Office Action Summary

10/670,559

KANEKO, TSUYOSHI

DETAILED ACTION

FIG. 8

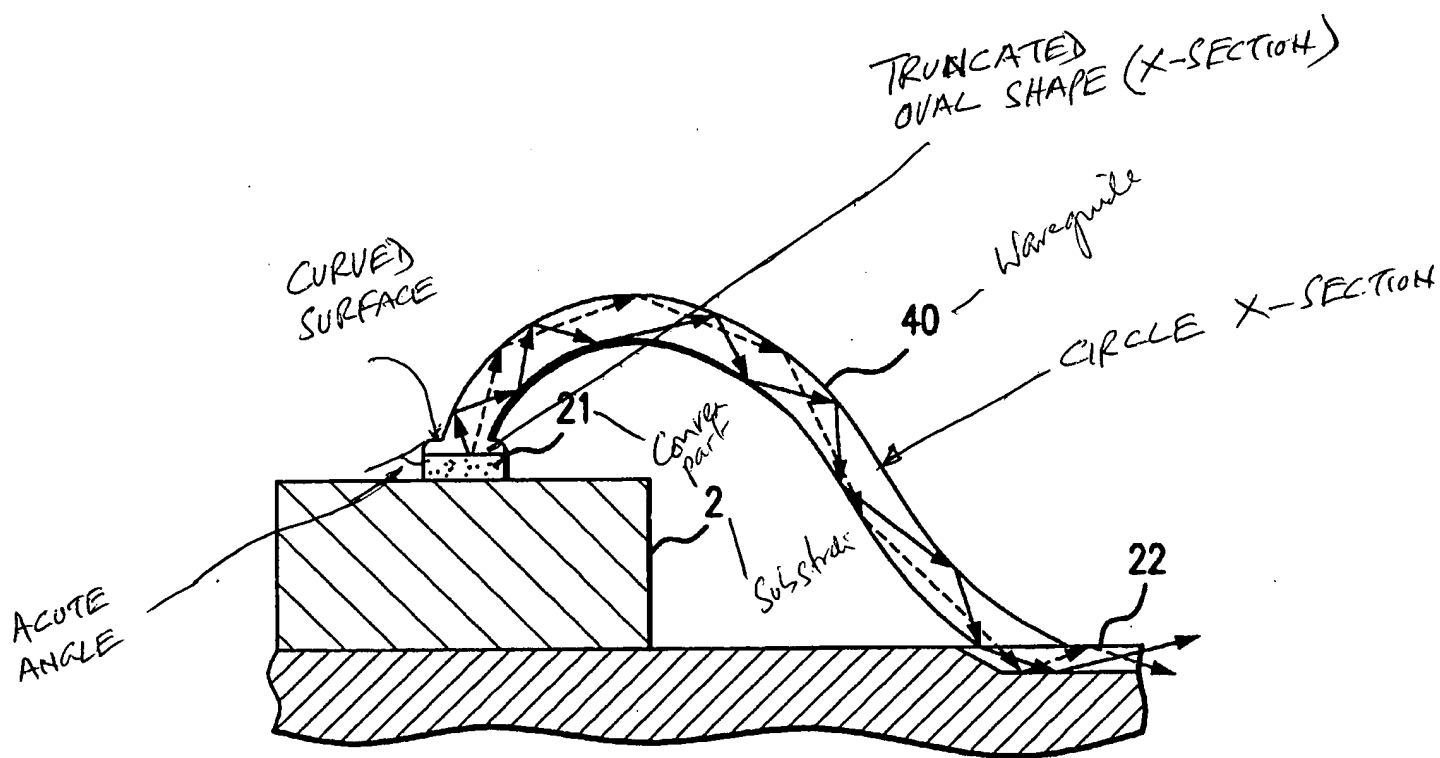
Okada et al discloses, **for claim 16**, a convex part (21) provided on a substrate (1, 2); and an optical waveguide part (40) provided solely on the convex part, the convex part having a lower refractive index than the optical waveguide pad, (PMMA has refractive index as 1.49, refer col. 8, lines 46-49 and Polyarylate has refractive index as 1.6, refer col. 9, lines 21-33, and according to claim 10 the material could be either PMMA or Polyarylate), **for claim 18**, a covering layer (20C) being formed around the optical waveguide (40), and the refractive index of the convex part and the refractive index of the covering layer are approximately equal (can be same material, see claim 10), **for claim 19**, the convex part being integrally formed with the substrate, **for claim 20**, a cross-section of the optical waveguide part being in the shape of a truncated oval (see marked figure 8, attached), **for claim 21**, a cross-section of the optical waveguide part being in the shape of a circle (see marked figure 8, attached), **for claim 22**, an upper surface of the convex part being a curved surface (see marked figure 8, attached), **for claim 23**, an angle made between an upper surface of the convex part and a surface that contacts the upper surface on a

side part of the convex part being acute (see marked figure 8, attached), **for claim 24**, an upper part of the convex part being formed in an inversely tapered shape (see figure 8), **for claim 25**, the optical waveguide being buried under a layer (20C) with a lower refractive index than the optical waveguide part (PMMA has refractive index as 1.49, refer col. 8, lines 46-49 and Polyarylate has refractive index as 1.6, refer col. 9, lines 21-33, and according to claim 10 the material could be either PMMA or Polyarylate), **for claim 26**, a first convex part (21) provided on a substrate (1, 2); an optical waveguide part (40) provided solely on an upper surface of the first convex part, a second convex part (22, "convex" is interpreted as part of the name) disposed in parallel with the first convex part; and a covering layer (20C, see figure 18B) that covers an optical waveguide part and is provided in part on an upper surface of the second convex part, **for claim 28**, an IC (2); and an optical element, **for claim 29**, an optical waveguide (40), **for claim 30**, an optical module (404), **for claim 31**, a convex part (21) provided on a substrate; and an optical waveguide part provided solely on the convex part, the convex part being disposed in parallel with the optical waveguide part (depend which part of the convex part is compared with which part of the optical waveguide).

- a) Okada does not disclose an "optical waveguide part provided solely on the convex part". It should be noted that looking at figure 8, it clearly shown that the optical waveguide part (40) provided solely on the convex part (21).
